**NOTICE OF A TYPE II DECISION ON A PROPOSAL IN
YOUR NEIGHBORHOOD**

CASE FILE NUMBER: LU 10-174651 DZM
KILLINGSWORTH STATION DESIGN REVISIONS

The applicant seeks Design Review approval for revisions to the previously approved land use case LU 08-160136 DZM AD Killingsworth Station, a four-story mixed-use apartment building on the vacant full block site at the northeast corner of Interstate Avenue and Killingsworth Street directly adjacent to the Killingsworth stop of the MAX Yellow Line. The revisions consist of the following items:

LANDSCAPE
PLAN

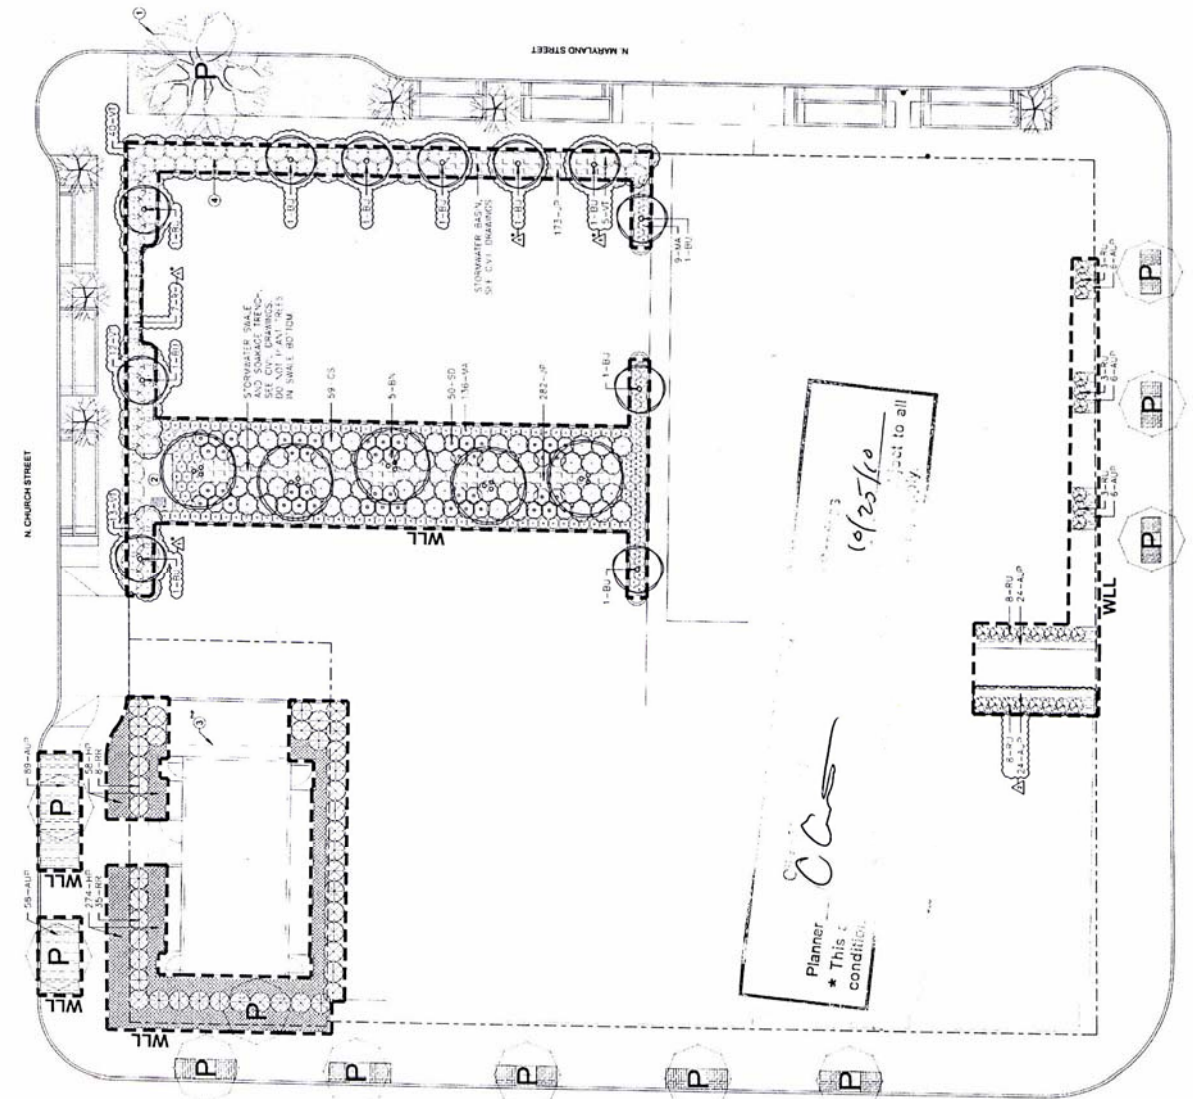
Modification #1 - PZC 33.266.130.G: Reduce the parking lot landscape buffer at N. Church Street from 5 feet to 2'-9" wide for 39'-6" along the public right-of-way and reduce the type of landscaping at the stormwater planter on N. Maryland from L2 screening levels to stormwater plantings with trees.

Findings: The parking area on the eastern portion of the Killingsworth Station site features a landscape buffer along its eastern edge, eco-roofs on its three carports, and also retains a large Heritage Tree. Both N Maryland and N Church Streets will have sidewalk improvements, newly planted parking strips and street trees, further improving the landscape buffers between vehicles and pedestrians. The narrow 39'-6" long portion of perimeter landscaping along N Church Street will be landscaped in the same manner as the remainder of N Church Street and will continue to soften the impact of the parking area on the pedestrian environment. While the eastern stormwater planter will not fully screen views of the parking area, it will be augmented by the wood slats strategically placed along the outside of the carport to screen headlights and views of vehicles from the street and nearby residential properties.

Findings: The reduced perimeter landscaping strip along N Church Street will continue to function as a buffer between the parking area and the sidewalk. Landscaping will be continuous along N Church Street, combined with sidewalk improvements and new street trees will reduce stormwater runoff from the parking area and minimize its visual impact on the neighborhood. The eastern parking lot view will be adequately screened by a combination of carport slats and stormwater plantings.

1. **33.266.130.G** Increase the length of the previously approved reduced parking lot landscape buffer at N. Church Street from 10'-0" to 39'-6" of 2'-9" landscape width along two separate sections of the public right-of-way and the reduction of landscaping at the stormwater planter on N. Maryland from L2 screening levels to stormwater plantings with trees.

ELEVATIONS

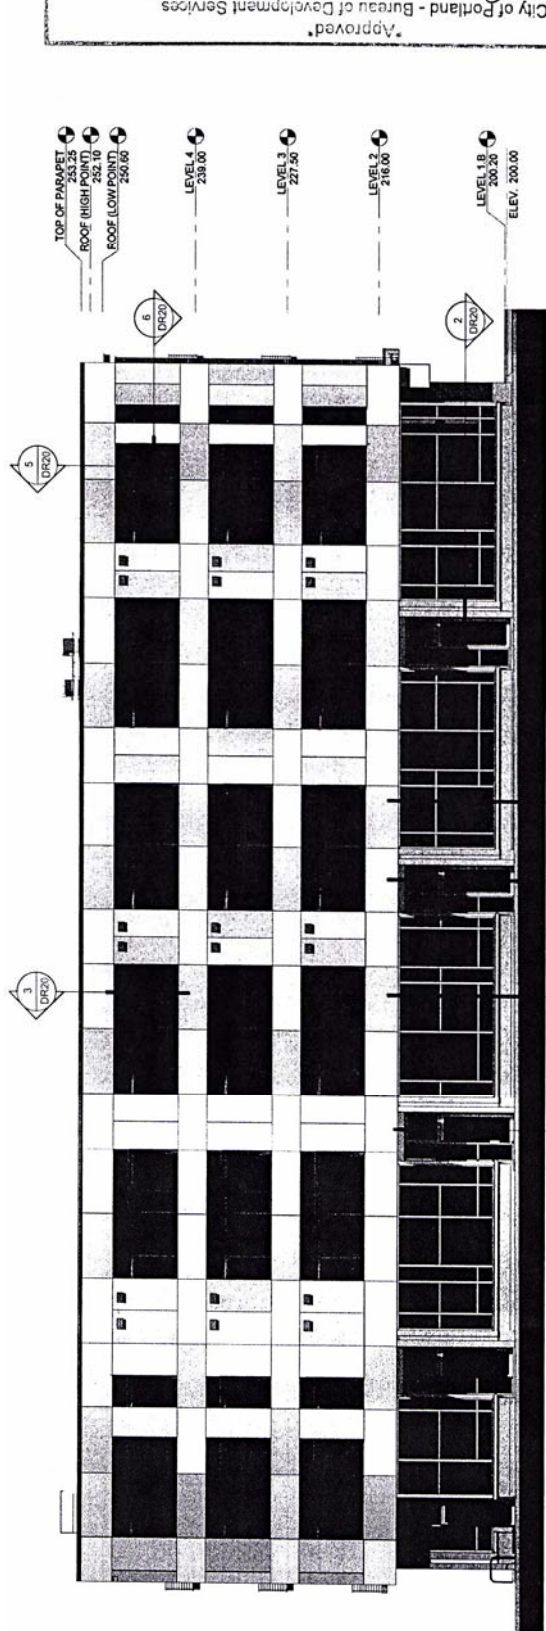
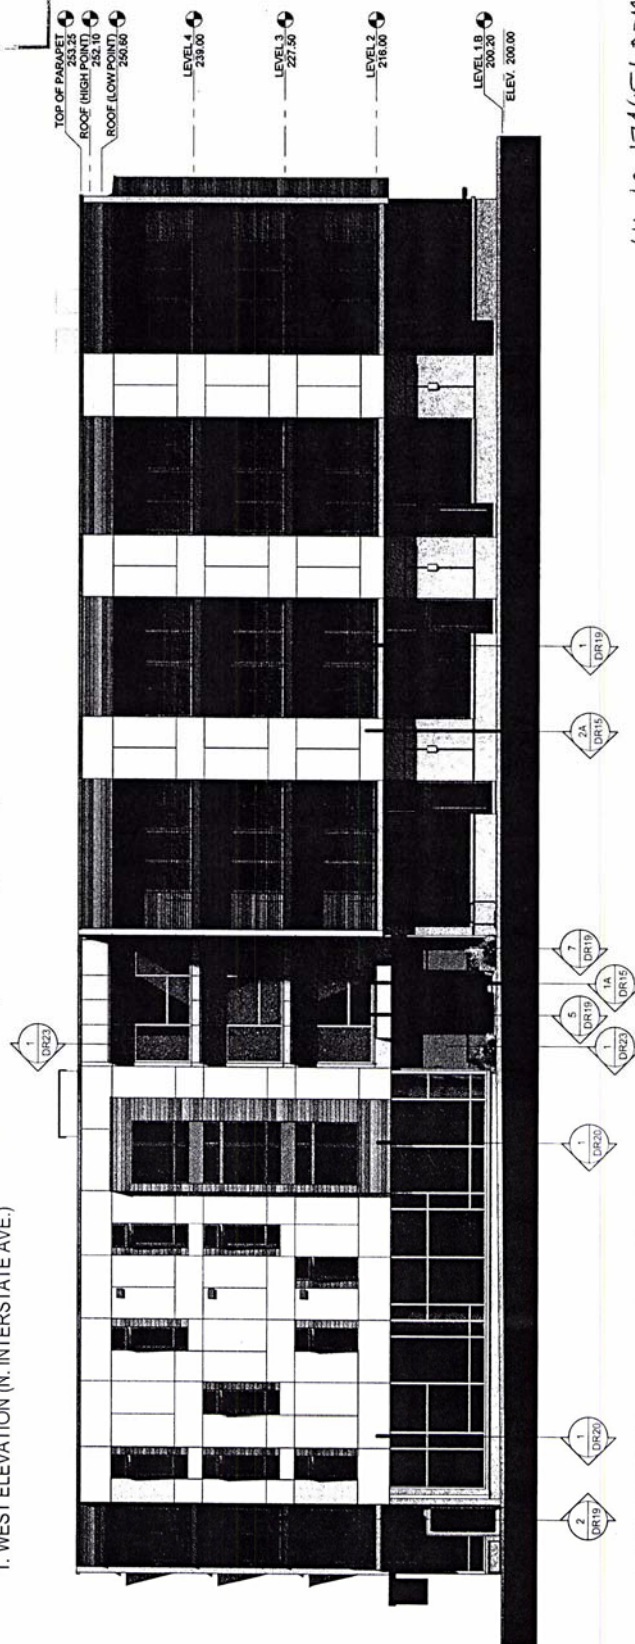
- Changes to window styles from separate transoms above main windows to multiple window units with wide horizontal integrated mullions;
- Replacement of the wood window screens on the West elevation with angled perforated metal sun screens on the West and a portion of the South elevations; material to match that used on building soffits;

Findings: The main residential entrance on N Killingsworth faces the bus transit station and is defined by a large overhanging metal canopy that is now supported by an equally impressive steel beam which adds to the scale and importance of the canopy as an entrance marker. The new slatted metal sun screens further define

Findings: The new perforated metal sun screen elements, multi-part windows, metal vents, and upper level metal siding are all reflective of design elements and materials already in place on the building. The overall shape and location of the building on the site remains unchanged as do the variety of exterior finish materials. The large wall planes around the building remain lively through the continued use of color, material, and pattern shifts. The proposed revisions retain the overall building design and present a cohesive composition of high-quality, long-lasting materials. *This guideline is therefore met.*

- Changes to window styles from separate transoms above main windows to multiple window units with wide horizontal integrated mullions;
- Replacement of the wood window screens on the West elevation with angled perforated metal sun screens on the West and a portion of the South elevations; material to match that used on building soffits;
